Attachment 1:
**Further information requested under Section 92 of the Resource
Management Act 1991**

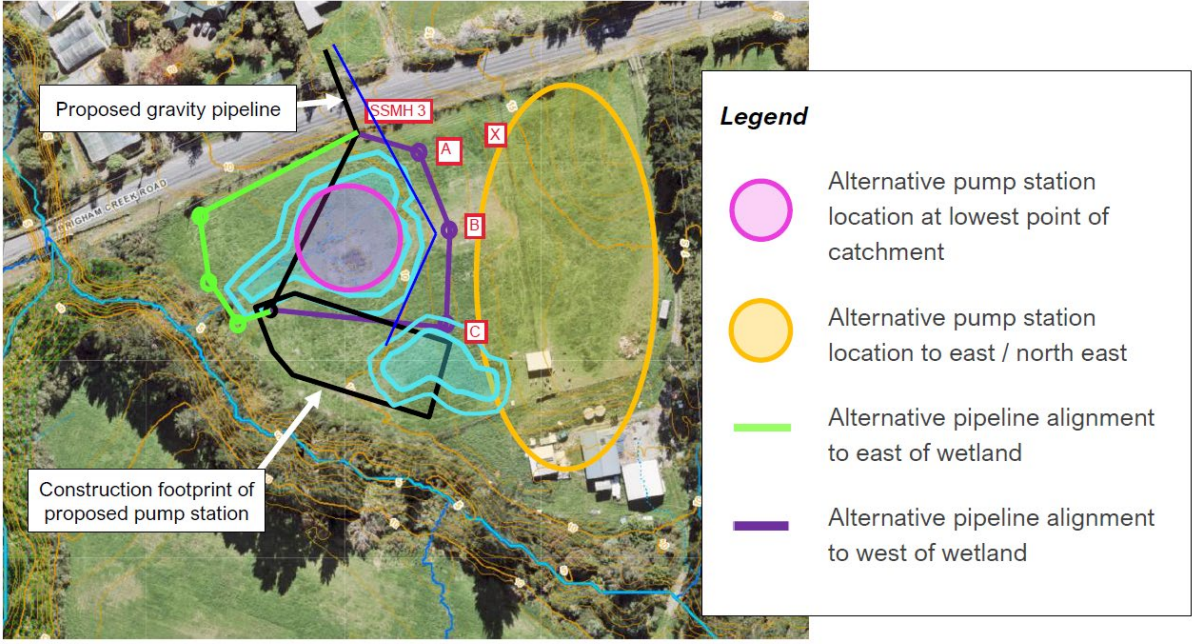
#	Category of information	Specific Request	Reasons for request
		 Figure 3. Considerations for pump station and gravity pipeline location	The Requiring Authority states that this will make the pipeline 3 metres deeper, and that the construction would then be 7m deep. However, from the above, 'Manhole A' is shown on the 11m contour, manhole B is at about 11.7m and manhole C about 11.5m, but this is at a completely unrealistic location as it should be further to the west. From the design drawing MH, manhole 'A' would have an invert level of about 6.70m. Therefore the depth of this manhole would be around 4.3m. This is a long way short of the stated 7.0m. For manhole 'A' to be at 7m deep it would need to be at RL 13.7; or around Location X.

#	Category of information	Specific Request	Reasons for request
		At a depth of 4.3m a trench shield can be used to minimise trench width, and therefore benching is unlikely to be required. Therefore the alignment shown, could likely move closer to the wetland, noting also the difference between the wetland boundary and the 1% AEP boundary. This would potentially mean that the 4.3m depth is likely to be less than 4m if the Requiring Authority were to attempt to make this design efficient. It is noted that throughout the alignment most manholes and trench lines are around 3m deep, so a 4m deep manhole is not exceptional. The deepest manhole is SSMH-4 at about 5.5m. It is noted that SSMH-3 if left in its current position, would likely need to be raised to the same depth due to the widening of Brigham Creek Road. The Requiring Authority state that an eastern alignment would require 3 additional manholes. However, it would be perfectly feasible to have an alignment from SSMH-3 to approximately 'B', and then into the WSL owned land, which would then only require one additional manhole. Alternatively, laying away from the BCR crossing without installing SSMH-3, could allow for no additional manholes, and remove the need for the extra deep SSMH-3. It is possible to reposition the pump station structures, including the inlet manhole based on what suits an eastern route, so the assumption of a western inlet manhole gives the longest possible gravity pipe, but this could be shorter. A rearrangement of pump station structures may be necessary anyway due to the discovery of Wetland D. This may also shorten the rising main length which would be a positive benefit, and offset any additional length of gravity main, which is likely to only slightly add to the depth of the station. If this were really a substantial factor, WSL could look at 'shallowing up' opportunities back at the existing pump station area. Therefore, I have concerns that the location of the pump station is not supported by a functional requirement assessment that demonstrates that alternative locations aren't possible.

#	Category of information	Specific Request	Reasons for request
ENG1	Engineering	Can you please consider the comments above, and reconsider the functional requirement for the location East of the wetland. Please include pipe route, including consideration of rearranging structures within the WSL pump station land in this assessment.	<i>To ensure a complete assessment has been considered.</i>
ENG2	Engineering	It appears that bringing in power and water supply from the alignment of the new Spedding Road and through the ROW area may be a better long term option, which would also avoid these services going through the toe of Wetland C. Can this please be considered? If not why not.	<i>The request it to ensure a complete assessment has been considered</i>
ENG3	Engineering and Planning	The functional requirement memorandum has BECA and Watercare in the header. Can you please clarify who prepared the memo, and provide the specialists who contributed?	<i>Currently, it has an employee from Watercare as the author, and I have concerns about the independence of the document.</i>
